**INSTRUCTIONS FOR MAINTENANCE AND OPERATION
OF BOGIE PETROL TANK WAGON TYPE 'BTPN'**

**Amendment No. 1 of August 1998 to Technical Pamphlet No.G-90,
Nov.'91 (Instructions for Maintenance and Operation of Bogie Petrol Tank
Wagon Type BTPN)**

PROCEDURE FOR REPAIR OF BARREL/ANCHORING TEE CRACKS

REFERENCE
REPAIR PROCEDURE
FOR CRACK IN BARREL

FIG. NO. 1
WHEN THERE IS NO CRACK.

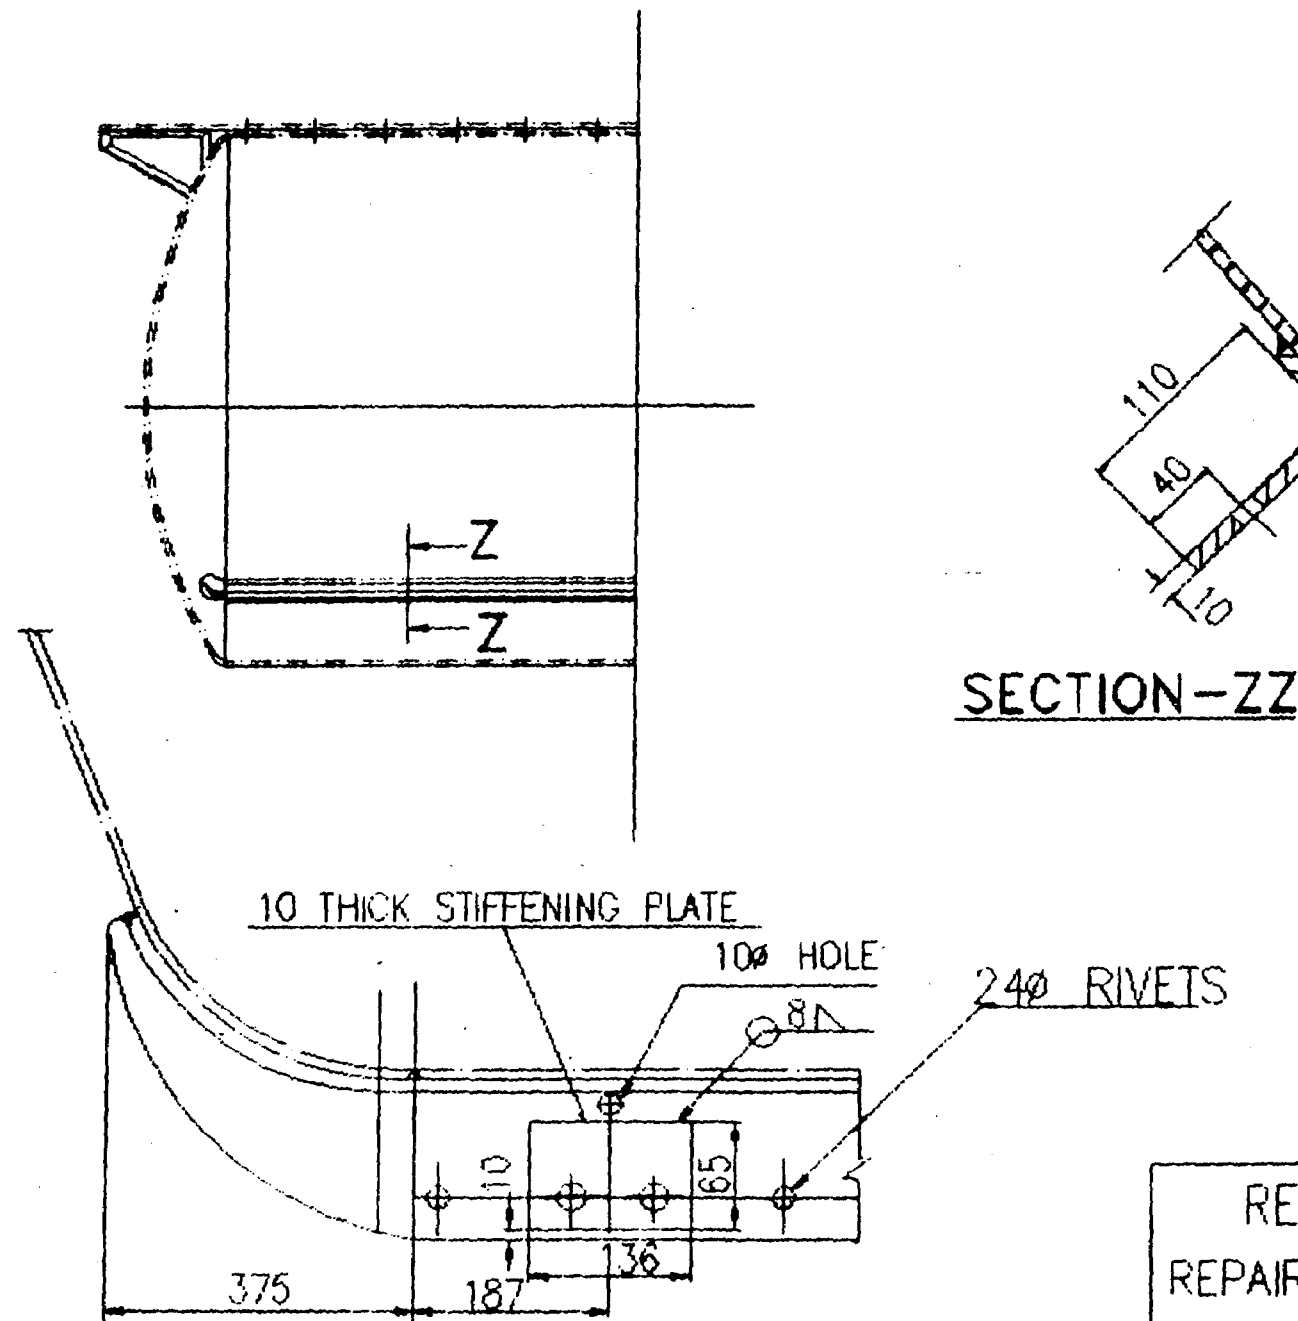
1. Case No. 1 If there is no crack (Fig.1).

- 1.1 Drill a 10mm dia arrester hole at the end of the welded joint of the web adjacent to the flange.
- 1.2 Remove 2nd and 3rd rivet and weld a patch plate all round as indicated in Fig.1 and secure it with nut and bolt.

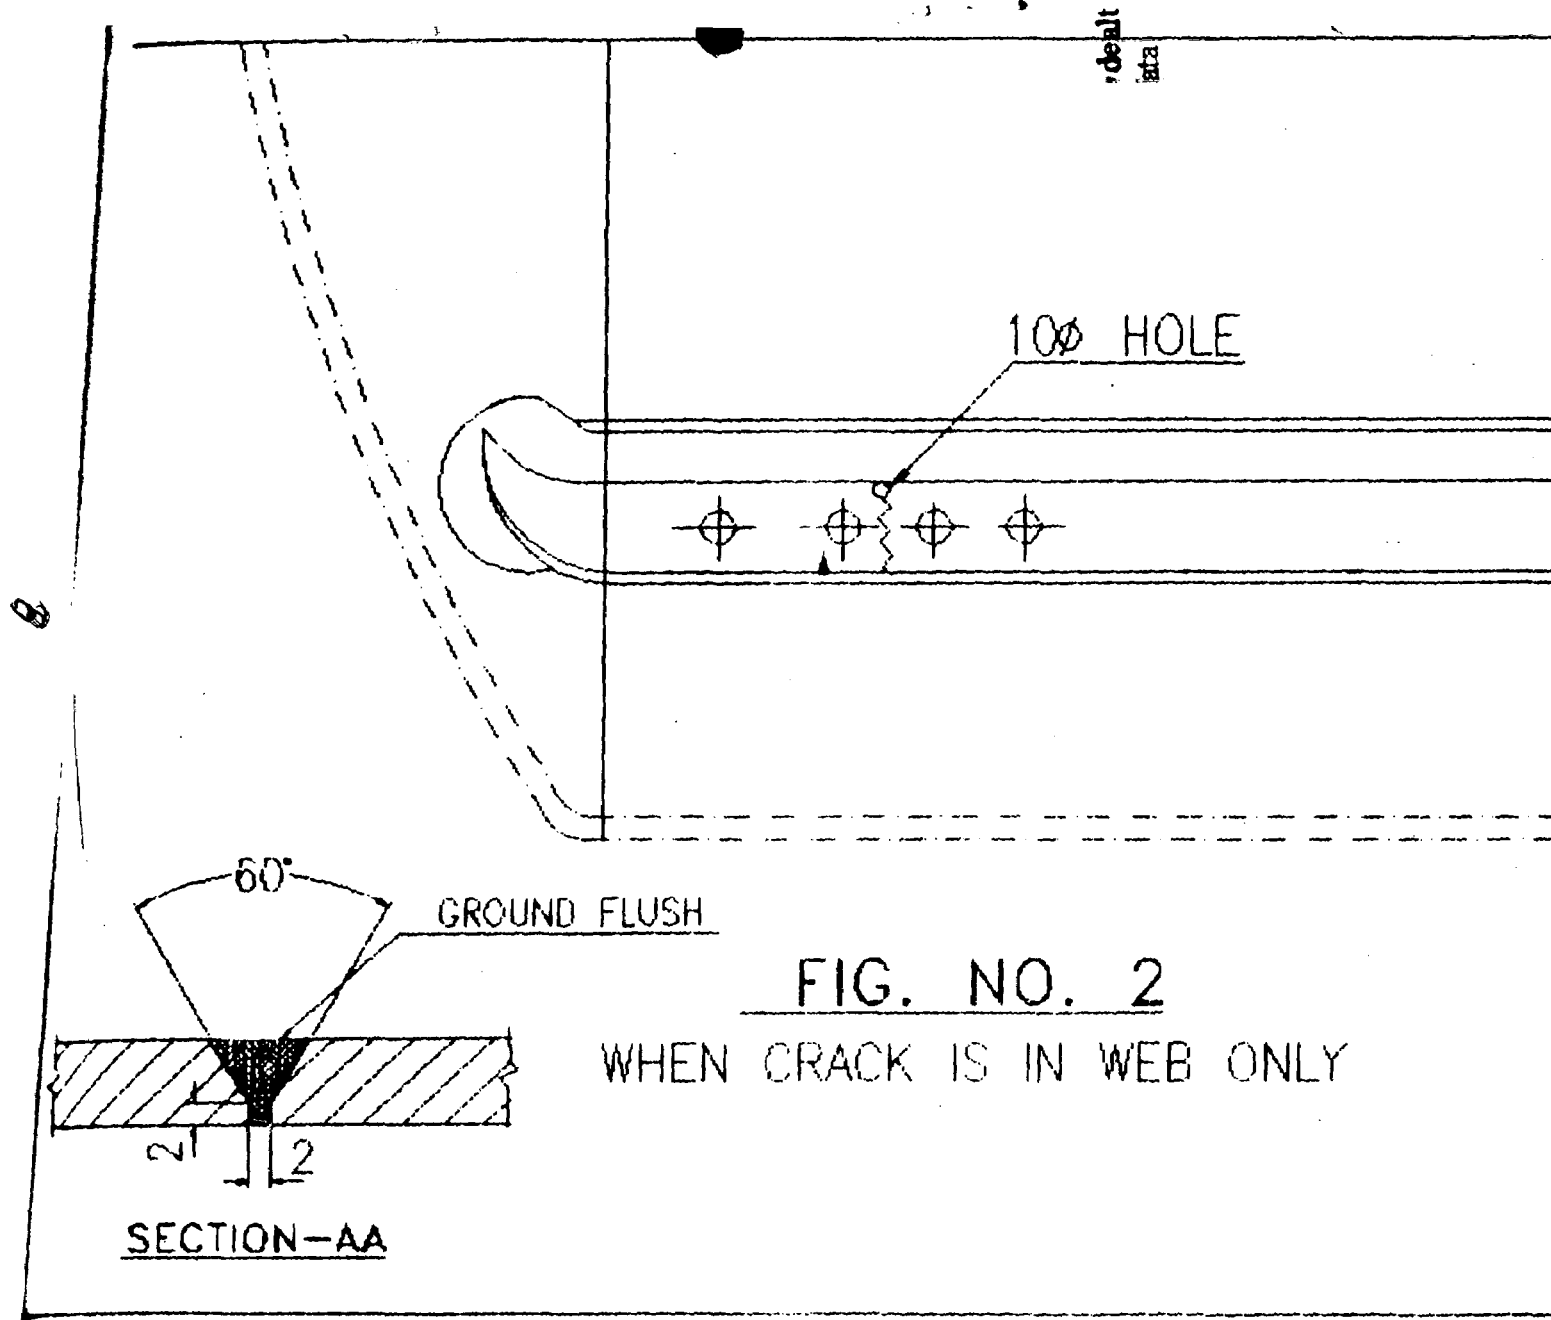
2. Case No.2 If crack has appeared only in the web of Anchoring Tee (Fig.2).

- 2.1 Perform operation 1.1
- 2.2 Gouge the welded joint of the web to the full depth.
- 2.3 Grind the area and clean the adjacent flange portion also and perform D.P. Test to check that the crack has been fully gouged and it has not propagated beyond the arrester hole.

- 2.4 Fill the groove with specified electrode.

- 2.5 Perform DP test of the welded area after flush ground.

FIG. NO. 3

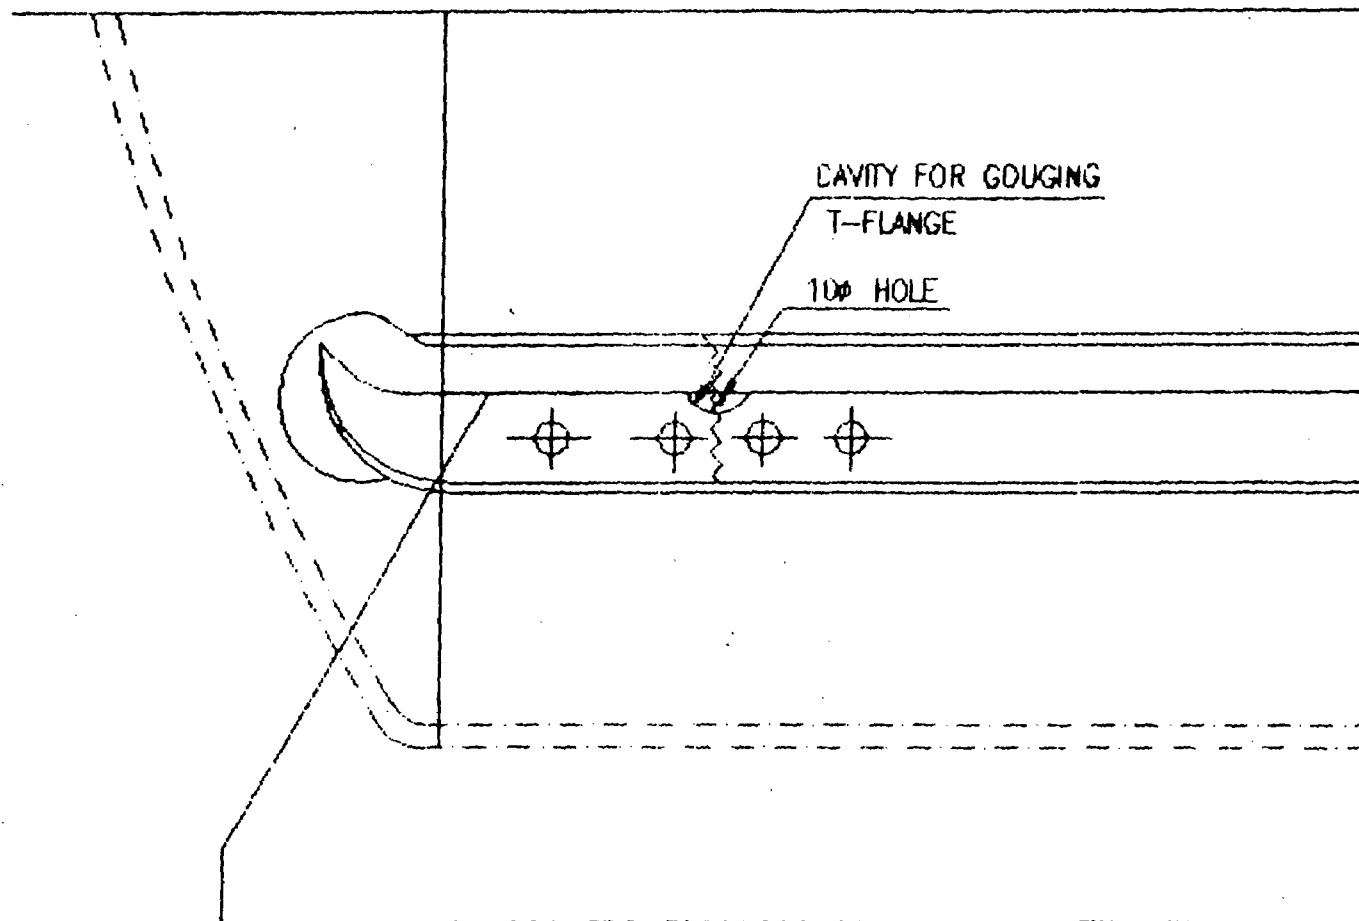
3 Case No. 3 If the crack has propagated to the flange (Fig.3).

- 3.1 Cut out a semi circular cavity in the web plate with the help of pneumatic chisel at the location of flange joint, just sufficient to make easy access of the gouging chisel & electrode.
- 3.2 Gouge the flange and web along the crack to the full depth.
- 3.3 Grind clean and perform DP Test to ascertain that the crack has not propagated to the barrel plate. If crack has propagated to the barrel also, proceed as in Case No.4.
- 3.4 Fill the groove in the flange with weld.
- 3.5 Fill the groove in the web with weld.
- 3.6 Perform DP Test after flush grinding.
- 3.7 Perform operation 1.1

FIG. NO. 4

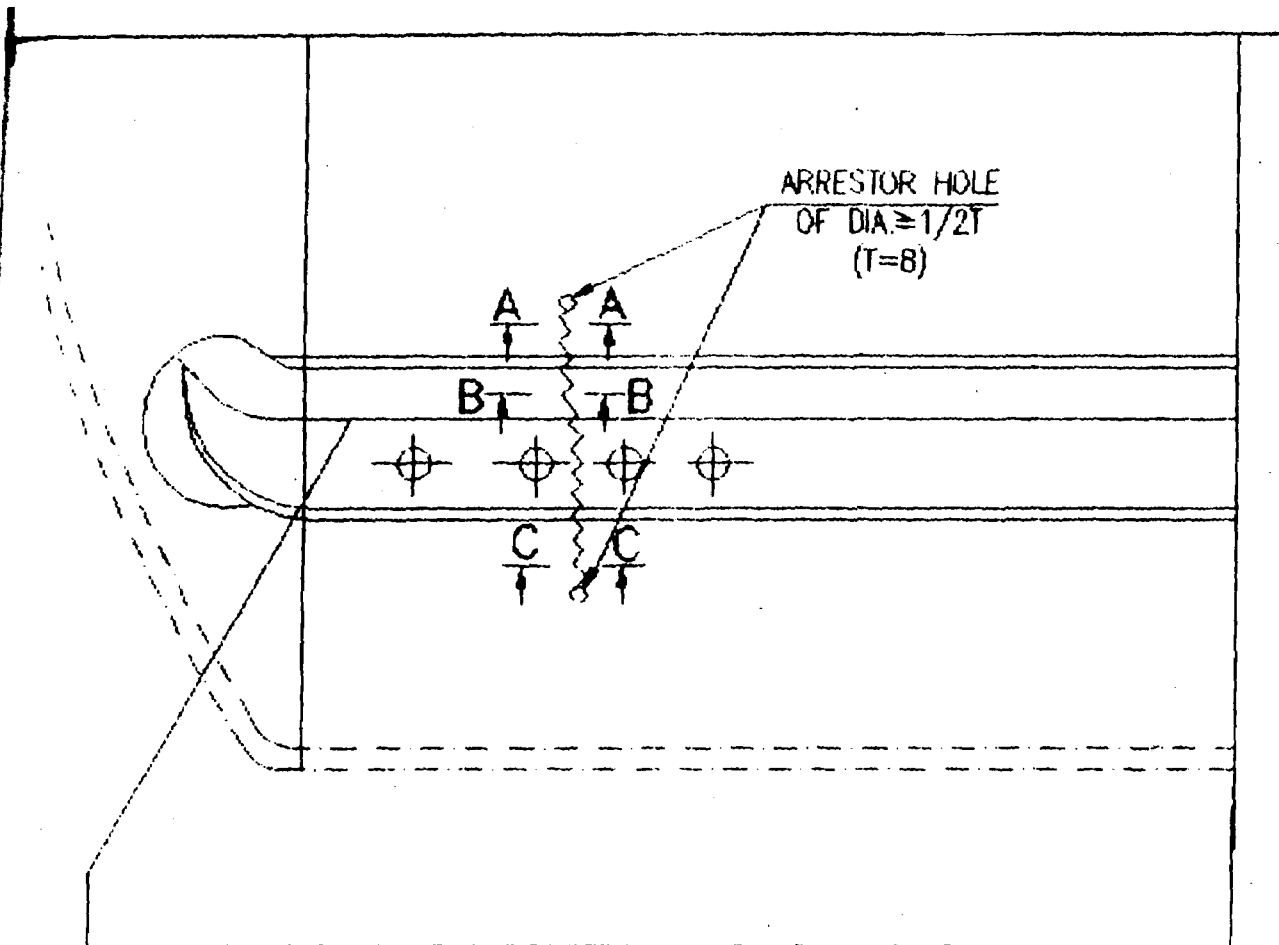
4 Case No.4 If the crack has propagated to the outer surface of the barrel plate (Fig.4).

- 4.1 Perform steps 3.1 & 3.2.
- 4.2 Grind clean and perform the DP test, both from inside and outside the affected area to check the extent of propagation of crack.

- 4.3 If the crack has not propagated to the full depth of the barrel plate, gouge the crack in the barrel also from the outsides. Before gouging the barrel crack, make an arrester blind hole at the end of crack to arrest its further progression during gouging. Perform DP test and then weld (root run) the barrel plate with 3.15mm dia electrode. Perform DP test after root run. Weld the groove with 4mm. dia electrode.
- 4.4 Flush ground the welded portion of the barrel from the outside and perform DP test along the barrel & flange.
- 4.5 Perform radiography of barrel plate weld and hydraulic test.
- 4.6 Perform operation 3.4 & 3.7.

5 Case No. 5 : If the crack has propagated to the full depth of the barrel plate.(Fig.4.)

- 5.1 After performing steps 4.1 & 4.2 if the crack is found to have propagated inside the barrel proceed as under:
- 5.2 Once the crack is located, gouging should be carried out from inside along the crack. While gouging through and through, care should be taken to keep the gap as small as possible. Here, gouging should preferably be carried out with a Pneumatic chisel. Before gouging two arrester holes should be drilled at both ends of crack.

- 5.3 The gouged area shall be cleaned properly and welding root run with 2.5mm/3.15mm dia electrode should be given from inside. Back plate, if necessary should be provided from outside along the barrel.

- 5.4 After root run, the weld deposit should be ground and DP tested to ensure crack free deposit.
- 5.5 Fill up the weld with 4.00mm dia. electrode.
- 5.6 Conduct DP test from inside after flush grinding. If crack is found in any DP test regouge and refill. Remove back plate (if provided).

- 57 Gouge the root run from outside till sound metal appears.
- 58 Clean the area properly and fill up with 4.00mm dia. electrode.
- 59 Conduct DP test from outside and flush ground the welding along the barrel. Fill up the gouged area of flange with 4.00mm dia. electrode.
- 510 Flush grind along the flange and conduct DP.
- 511 Perform steps 4.5 & 4.6.
- 512 In case of multiple cracks suitable inserts may be used to facilitate easier welding. Patch plate of adequate size and contour to cover the entire welding crack from inside the barrel may be provided with inserts or otherwise as felt necessary.
